**Further information**

On 2<sup>nd</sup> February 2026, Cavan County Council were seeking further information for the large-scale residential development on lands at Lisdaran Townland, Loreto Road, Cavan Town as information previously submitted was not adequate to enable a decision to be made. In accordance with the provisions of Article 33 of the Planning and Development Regulations, 2001, as amended, we are hereby required to submit the further information as set out on the below Schedule.

The key items in relation to Landscape matters have been addressed by Parkhood below. For all other items please refer to the relevant consultant’s response.

Fig 2. Extract plan from drawing L1005 Boundary Proposals Plan

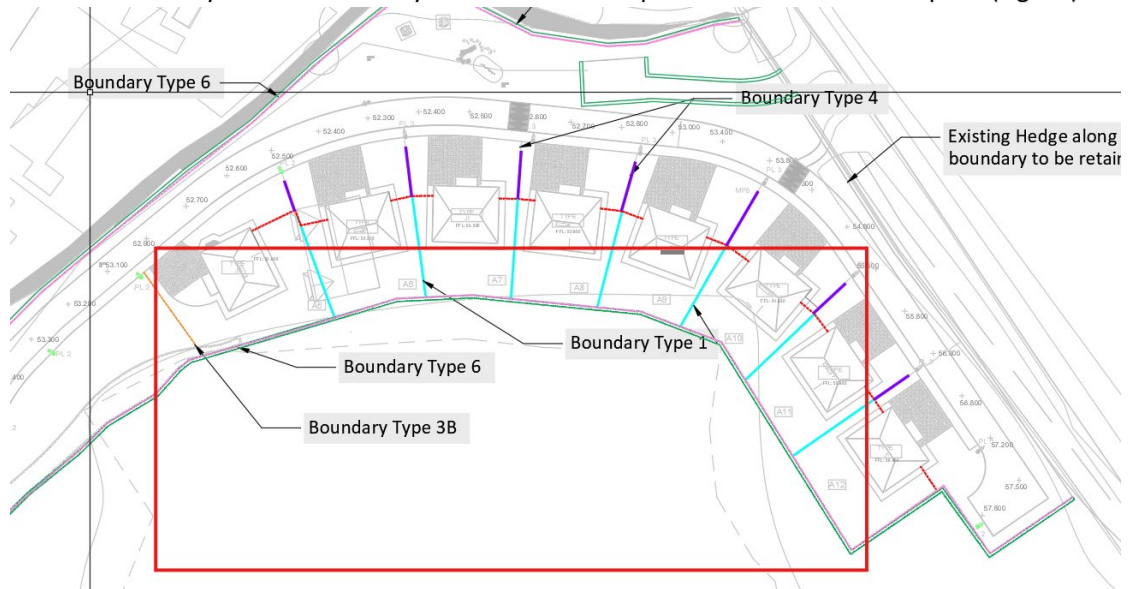
<b>Item 2</b>	<b>FI Request</b>
	<p>The provision of adequate boundary treatment is considered as key importance in terms of not only safety, but also visual and residential amenity. The provision of same as proposed is not considered acceptable and would benefit from enhancement at a number of locations. The applicant is requested to submit a revised boundary treatment plan for the proposed development incorporating a higher standard of provision.</p>
	<b>Parkhood Response</b>
	<p>Parkhood have reviewed the boundary treatment plan site wide and have made the below amendments.</p> <ol style="list-style-type: none"> <li>Boundary Treatment Type 6 post and wire fence (See fig.1) has been modified to include hedge planting to enhance the visual amenity where there are particularly long runs proposed site wide. Please refer to drawing L1001 &amp; 1005.</li> </ol>  <p>6 1.2M HIGH POST AND WIRE FENCE WITH HEDGE PLANTING SCALE 1:50</p> <p>Fig. 1 Boundary Type 6 from L1005 Boundary Proposals details</p>

2. To further clarify, the boundary to the rear of the lower residential dwellings is Type 6 as above with hedge planting. Note there is a bank below the existing tree line along this section of the site acting as a natural boundary so a soft boundary treatment at the top of the bank seemed adequate (Fig 2-3)

Fig.7 Extract Plan updated to show Areas 1 & 2

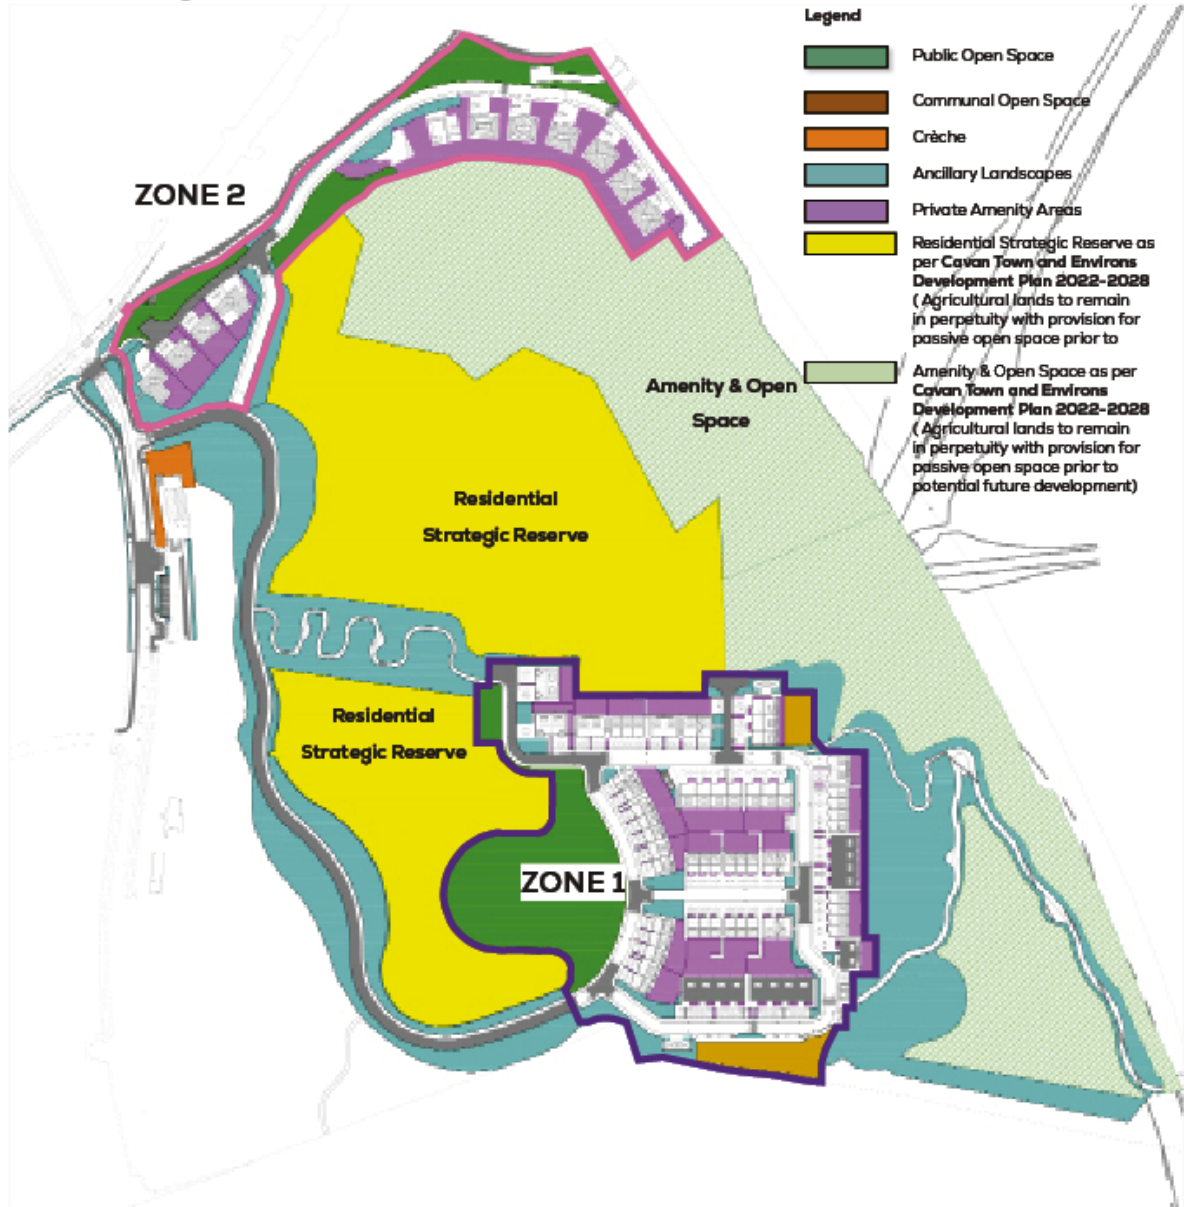
**Item 13** Reference is made to two areas within the site boundary that they have not been denoted on the site layout plan for inclusion as part of this development, future development or open space provision. Area 1 is located to the north, west and south of the Recorded Monument (CV020-057 Rath Site and CV020-58--- Rath) and Area 2 is located to the east of the site abutting the NSRL. It is accepted that the ground levels of both areas are challenging and although not suitable for the provision of usable open space, the provision of passive open space should be considered. The applicant is requested to submit a revised open space strategy for the proposal which shall include both areas and outline proposals for the future management of same. This open space strategy should also give due regard to the recommendations outlined in the submission from the Department of Housing, Local Government and Heritage with particular regard to the Recorded Monument (CV020-057 Rath Site and CV020-58--- Rath) and archaeology.

Parkhood have updated the Landscape Design Report 7348-PHL-00-ZZ-RP-L-0001, page 11 Landscape Diagrams - Open Space Hierarchy to include Areas 1 & 2 as per above.  
As per the Cavan Council Development Plan 2022-2028 these areas fall under Residential Strategic Reserve & Amenity open Space. The lands are currently agricultural and will remain in perpetuity with provision for passive open space prior to future development (Fig.7)
